PRODUCT UPDATE

CG03137

1ft (0.3m) 18 AWG Outlet Saver Power Extension Cord (NEMA 5-15P to NEMA 5-15R)

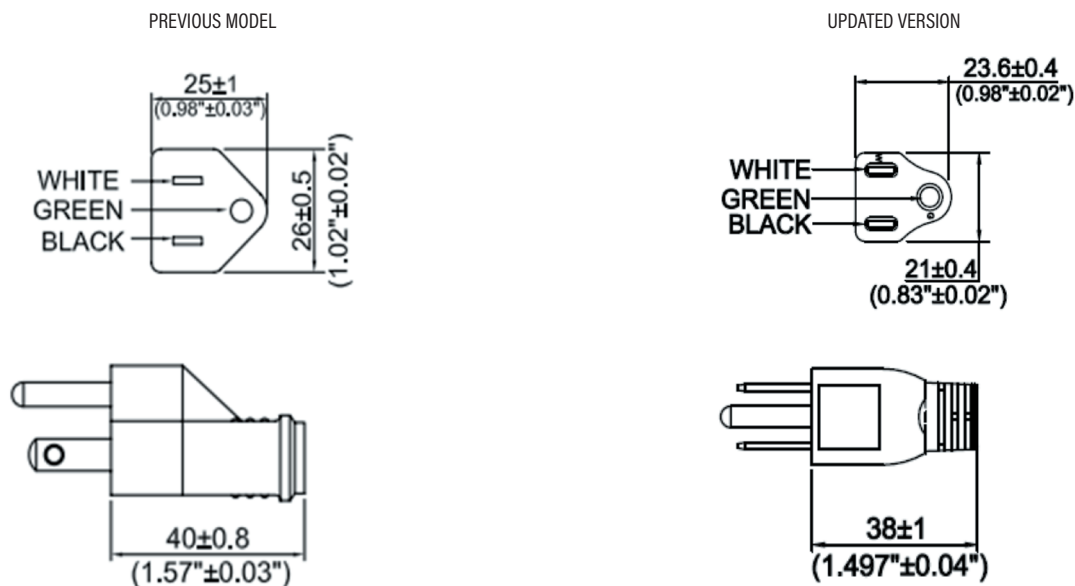
1. The NEMA 5-15P now features a minor visual change with double lines around the pins.
2. The NEMA 5-15P connector dimensions have been changed from: 40mm \pm 0.8 mm x 26mm \pm 0.5mm x 25mm \pm 1mm (LxWxH) to: 38mm \pm 1mm x 21mm \pm 0.4mm x 23.6mm \pm 0.4mm (LxWxH).
3. The temperature rating has been upgraded from 75°C to 105°C to comply with the latest UL and CUL standards.
